SUBJECT: POINT BEACH NUCLEAR PLANT, UNITS 1 AND 2 - ISSUANCE OF
AMENDMENTS RE: LOSS OF POWER DIESEL GENERATOR START
INSTRUMENTATION (TAC NOS. MD0936 AND MD0937)

These amendments revise TS 3.3.4, "Loss of Power (LOP) Diesel Generator (DG) Start and Load Sequence Instrumentation," and surveillance requirement 3.3.4.3.b, to modify the TS title and correct nonconservatisms in the allowable values for the degraded voltage time delay.

SAFETY EVALUATION BY THE OFFICE OF NUCLEAR REACTOR REGULATION

POINT BEACH NUCLEAR PLANT, UNITS 1 AND 2

Figure 1: Degraded Voltage Protection Loop Block Diagram:

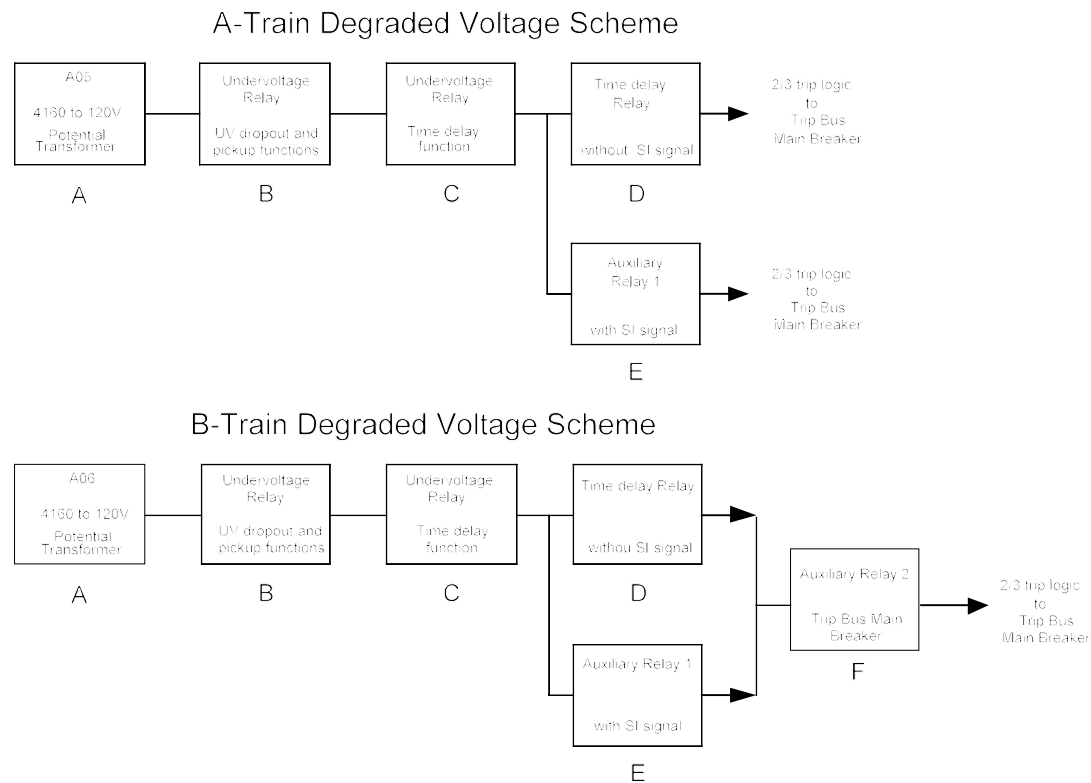
Degraded voltage protection on each 4.16 kV safeguards bus is provided by three degraded voltage channels, each with a degraded voltage relay with voltage and time delay settings; and a bus time delay, with a separate time delay setting. Each degraded voltage channel is configured as shown in Figure 1.

Blocks A, B, C, and E provide degraded voltage protection coincident with an SI signal. Blocks A, B, C, and D provide degraded voltage protection without an SI signal present. When the safeguards bus voltage remains below 95 percent of the nominal voltage, the degraded voltage relay B drops out and starts the time delay relay C. After timeout of the relay C, auxiliary relay E will be energized with SI signal present and time delay relay D will be energized without SI signal present.

The licensee performed statistical analysis on the As-Found/As-Left plant calibration data for Block C and Block D relays from 1996 and 2004. The data set was tested for normalcy by determining skewness and kurtis. The standard deviation was calculated using an Excel STDV function. The standard deviation was multiplied by a factor based on the sample size in order to determine a 95 percent confidence level drift value including M&TE uncertainty and device accuracy. The 95/95 drift value was calculated to be ± 0.92 percent of the setting for Block C and ± 2.75 percent of the setting for Block D relays.

Maximum and minimum ALs were calculated from SLs by deducting the operating time of the Block E and F relays. The nominal trip setpoints for the Block C and D relays were calculated by deducting the maximum time delay total loop error from the maximum AL.

Figure 3: Degraded Voltage Time Delay with a Safety Injection Signal

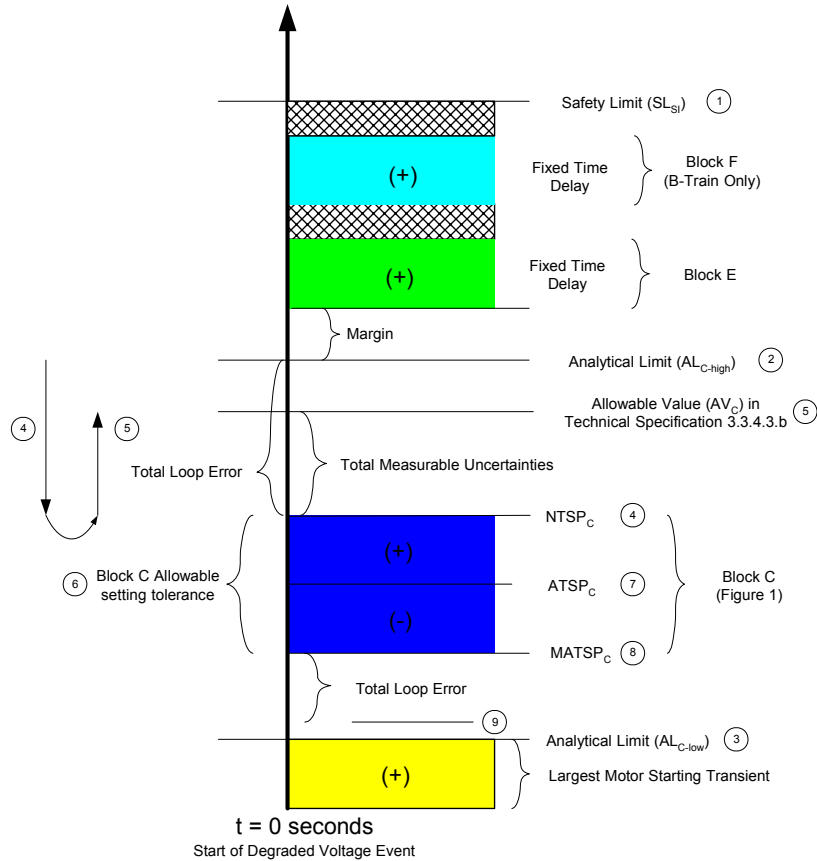
The licensee also proposed to change the AV for degraded voltage time delay with SI signal present from "< 6.47 seconds" to "< 5.68 seconds" and the AV for degraded voltage time delay without SI signal present from "< 54 seconds" to "< 39.14 seconds." The licensee stated that this reduction in AV results from both its recent reanalysis of PBNP Calculation 2004-0002, "AC Electrical System Analysis," Revisions 0 and 1, and the reassignment of the second AV to the bus time delay relay. The current TS time delay AV represents the combined time of both time delay relays. The licensee stated that the present AVs for these settings were found to be non-conservative and could have resulted in certain safety-related motors tripping on overcurrent during a degraded voltage event. The revised TS AVs will ensure that the safety-related components will have adequate voltage, which is necessary to maintain continuous operation and starting capability during worst-case plant loading conditions and to protect operating loads from damage or tripping on overcurrent during degraded voltage conditions. The licensee has instituted administrative controls on these TS SR values, pending NRC approval of the proposed TS change.

In calculating the setpoints, the licensee used 6 seconds as the maximum safety limit (SL) and 4.6 seconds as the minimum analytical limit (AL) with SI signal present and 48 seconds as the maximum SL and 27.85 seconds as the minimum AL without SI signal present.

The licensee selected the maximum time delay of 6 seconds (maximum SL) for the degraded voltage relay setpoint calculations to ensure that all safety-related equipment supplied by the 4.16 kV and 480 V safeguard buses is protected from tripping on overcurrent, while connected to offsite power under a degraded voltage condition, and to ensure that the DGs are ready to load within 15 seconds of the event. To support this 15-second DG start time, the PBNP Final Safety Analysis Report Chapter 14 Accident Analysis requires a maximum time delay of 9.3 seconds for degraded voltage relay. This maximum SL of 6 seconds, with a revised calculated AV of 5.53 seconds, is less than the current AV of 6.47 seconds. The NRC staff finds that the maximum time delay of 6 seconds, with SI signal present, is acceptable; this change will eliminate undesired tripping of the safety-related loads, while providing enough time for the DGs to start in less than 15 seconds.

The licensee selected a minimum allowable time delay of 4.6 seconds (minimum AL) to ensure that the time delay is long enough to ride through the starting of safety related loads in a loss-of-coolant accident without prematurely separating from the preferred offsite power source. The NRC staff finds that the minimum allowable time delay of 4.6 seconds, with SI signal present, will ensure starting of the loads in time and is, therefore, acceptable.

The licensee's Calculation 2004-002, Revision 0, lists the following parameters for the above Degraded Voltage Time Delay with a Safety Injection Signal:

Maximum Safety Limit:	6 seconds	Analytical Limit High:	5.92 seconds
Allowable Value:	5.68 seconds	NTSP:	5.63 seconds
ATSP:	5.53 seconds	MATSP:	5.43 seconds
Minimum Safety Limit:	4.6 seconds

Figure 4: Degraded Voltage Time Delay without a Safety Injection Signal

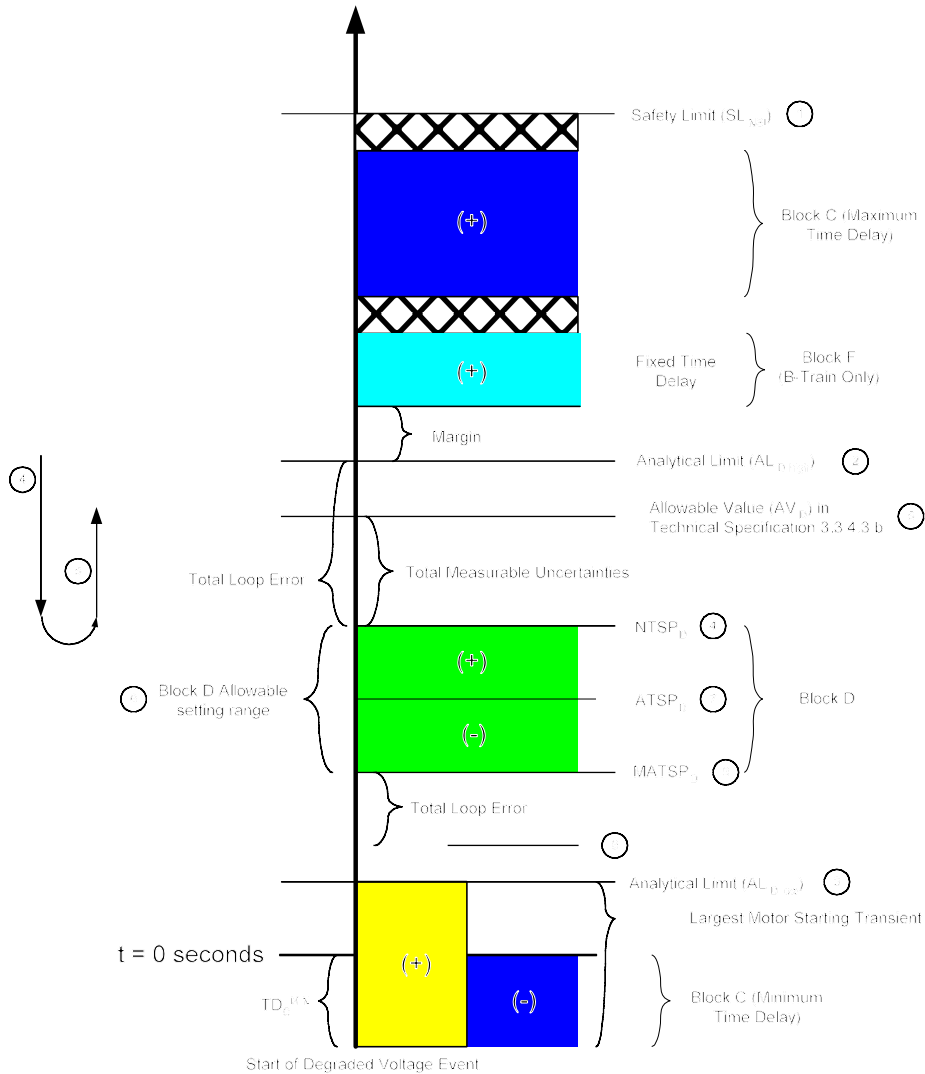
The licensee selected a maximum SL, without an SI signal, of 48 seconds to ensure that all running safety-related equipment supplied by the 4.16 kV and 480 V safeguard buses is protected from tripping on overcurrent while connected to offsite power under degraded voltage conditions during normal plant operation. This maximum time limit of 48 seconds, with the revised calculated AV of 39.14 seconds (this revised value represents bus time delay relay, rather than representing a combined time delay relays from the two relays in series), is less than current AV of 54 seconds (this value currently represents the sum of the two time delay relays, one from the degraded voltage relay and the other from the bus time delay relay). The NRC staff finds that the maximum time delay of 48 seconds, without SI signal present, will eliminate undesired tripping of the safety-related loads and is, therefore, acceptable.

The licensee's analysis indicates that a minimum SL, without an SI signal, of 33 seconds is required to ensure the time delay is long enough to prevent the unnecessary separation from the preferred source during a voltage transient for the largest motor during normal plant operation. Subtracting the minimum calculated time delay of 5.15 seconds for the bus degraded voltage relay (Block C relay of Figure 1), the minimum AL is calculated as 27.85 seconds. The NRC staff finds that the minimum allowable analytical time delay of 27.85 seconds, without SI signal present, will ensure starting of the loads in time and is, therefore, acceptable.

The licensee's Calculation 2004-002, Revision 0, lists the following parameters for the above Degraded Voltage Time Delay without a Safety Injection Signal:

Maximum Safety Limit:	48 seconds	Analytical Limit High:	42.05 seconds
Allowable Value:	39.14 seconds	NTSP:	38.09 seconds
ATSP:	36.99 seconds	MATSP:	35.89 seconds
Minimum Safety Limit:	27.85 seconds
